SERVICE BULLETIN

Subject: Bell 206L/407 Manual Release Cable

Helicopters Affected: Bell 206L-1, 206L-3, 206L-4, and 407 model helicopters

Service Bulletin
Document: 159-030-00
Revision: 0 Date: August 1, 2011

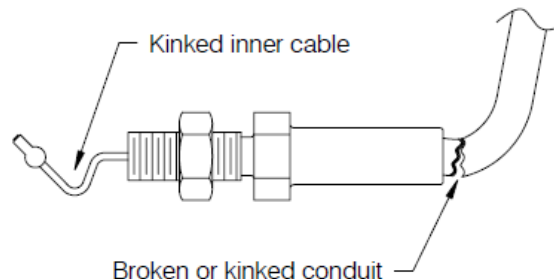
1) *Replace* Manual Release Cable P/N 268-004-00 *or* 268-011-00 with Manual Release Cable P/N 268-004-01. The redesigned Manual Release Cable incorporates more flexible conduit, improved end fittings, and increased length. These improvements extend the service life of the manual release cable.

Figure 1 Manual Release Cable (200-259-00 kit configuration shown)

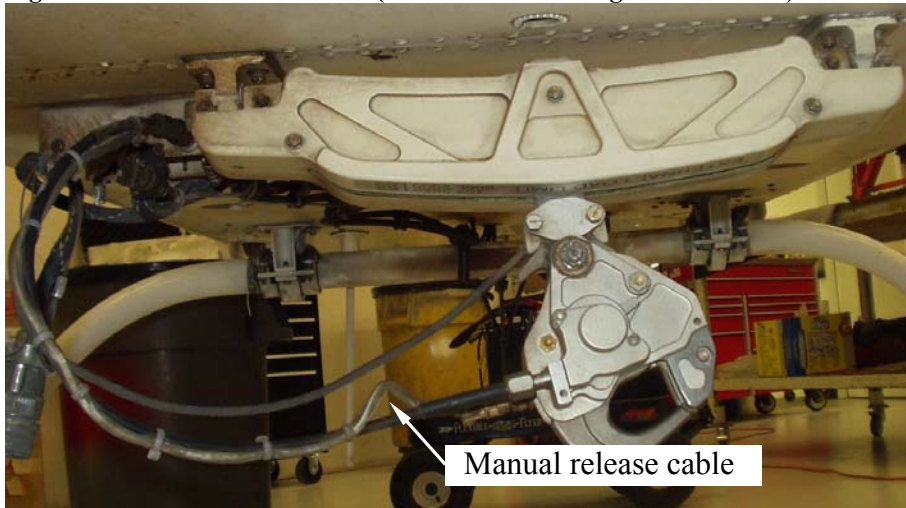
Description: Onboard Systems has had reported cases of failure of the Manual Release Cable P/N 268-004-00. This cable is used to connect the release mechanism of the cargo hook to the fixed manual release cable as part of the backup release system (see Figure 1). Failure of the mechanical release cable can cause an uncommanded release.

Accomplishment Instructions: Replace the existing Manual Release Cable (P/N 268-004-00 or P/N 268-011-00) with the new Manual Release Cable (P/N 268-004-01) per the following instructions. The new cable can be identified by the part number marking on the cable housing.

Figure 4 Manual Release Cable Installation (528-023-01 cargo hook shown)

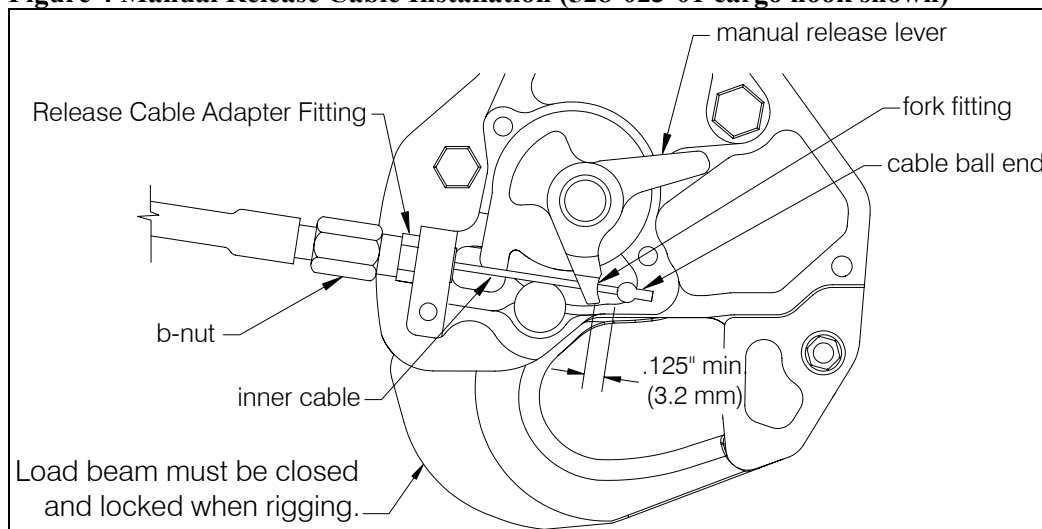
- At the cargo hook insert the inner cable through the release cable adapter fitting and the fork fitting (see Figure 4)
- Thread the manual release cable's b-nut onto the release cable adapter fitting and tighten securely.
- Verify the Manual Release Cable is rigged correctly by rotating the manual release lever in the clockwise direction to remove free play (this is felt as the lever rotates relatively easily for

several degrees before free play is taken up) and measure the gap between the cable ball end and the fork fitting as shown in Figure 4. This gap should be a minimum of .125 inches (3.2 mm).

Failure to appropriately rig the manual release cable free play will result in uncommanded release of load.

Adjustment of the manual release cable free play must be accomplished with the cargo hook in the closed and locked position.
